# **EXHIBIT D**

January 6, 2017

**Subject: Comments on the Draft Environmental Impact Report Prepared for the Suncrest Dynamic Reactive Power Support Project**

**Figure 1.** Site conditions at proposed SVC site on 22 December 2014.

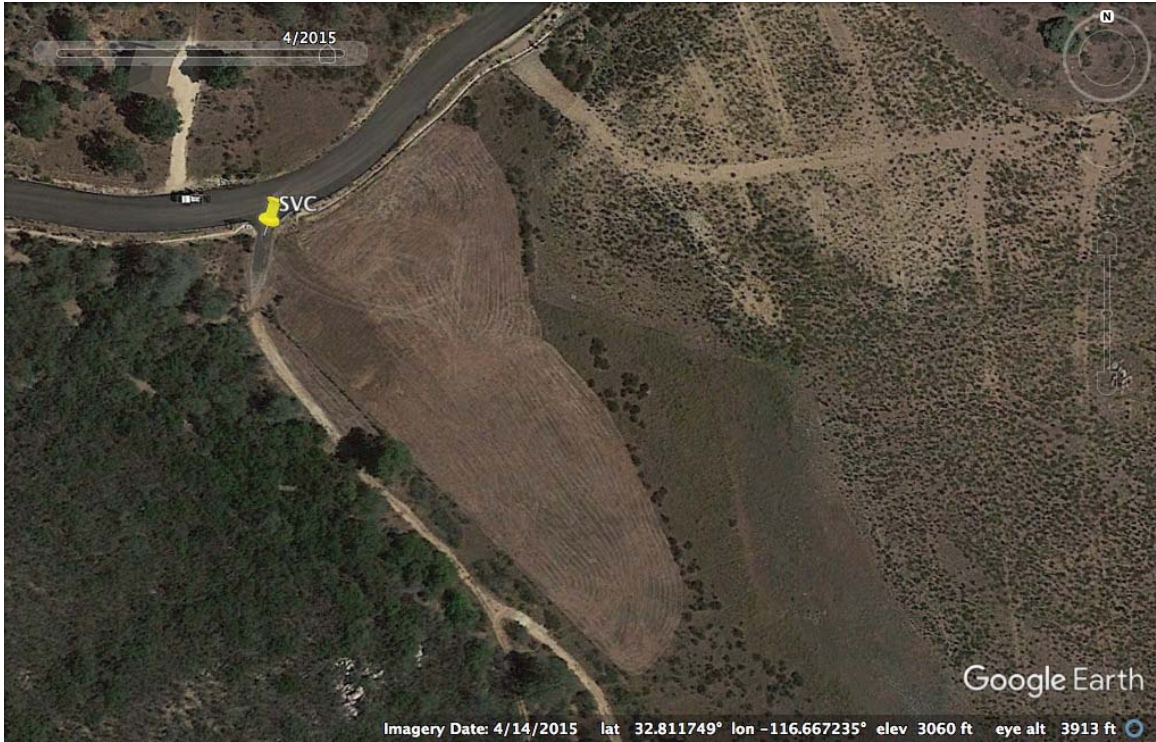
Third, the DIER inappropriately defined the environmental baseline as the conditions that were present shortly after the property owner cleared and/or graded the site.<sup>21</sup> Biological resource mapping requirements imposed by the County of San Diego state:

The property owner cleared the site sometime between December 22, 2014, and April 14, 2015 (Figures 1 and 2). The property owner then installed a dirt road and large water tank sometime between April 14, 2015, and March 22, 2016 (Figures 2 and 3). Although the Proponent’s Environmental Assessment (“PEA”) suggests the water tank was installed for SDG&E’s restoration efforts, that information appears inconsistent with the timing of SDG&E’s restoration program (which was deemed complete in March 2016).<sup>23</sup> As reported in the PEA, the tank will provide an on-site water source for the water needed during Project construction in the event that reclaimed water sources are unavailable.<sup>24</sup> Furthermore, although the PEA claims the “ruderal” portion of the Project site has been subject to repeated disturbance over the past two decades,<sup>25</sup> that claim is inconsistent with time-lapse imagery available through Google Earth. Nevertheless, the amount of land that was cleared and graded by the property owner far exceeds the amount of land that would be needed to install a water tank for SDG&E’s restoration efforts. Thus, existing evidence strongly supports the inference that grading and clearing were conducted in preparation for the proposed Project and not for some other purpose

(e.g., as part of the property owner’s routine maintenance of the property). As a result, the environmental baseline for the “ruderal” portion of the Project site needs to be revised to reflect the conditions present when the property owner cleared the site.
